## Author Response to Reviews of

# Under-ice acoustic navigation using real-time model-aided range estimation

*Journal of the Acoustical Society of America*

### 2.4 line 89 → 97 (pg. 6)

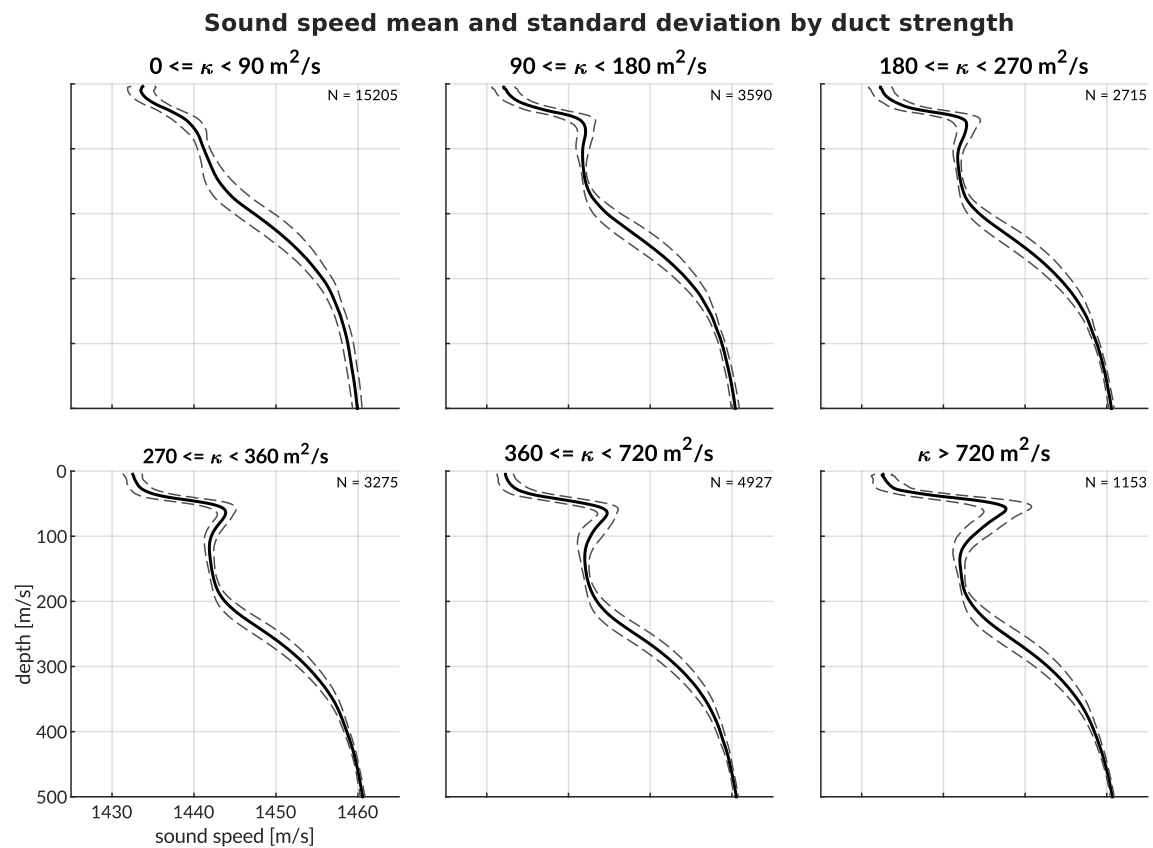
*Is the 'lens' the warm water? Or a combination of layers? What does 'lens' mean acoustically? Normally in ocean acoustics people refer to ducts and layers.*

Please see comment 2.1.
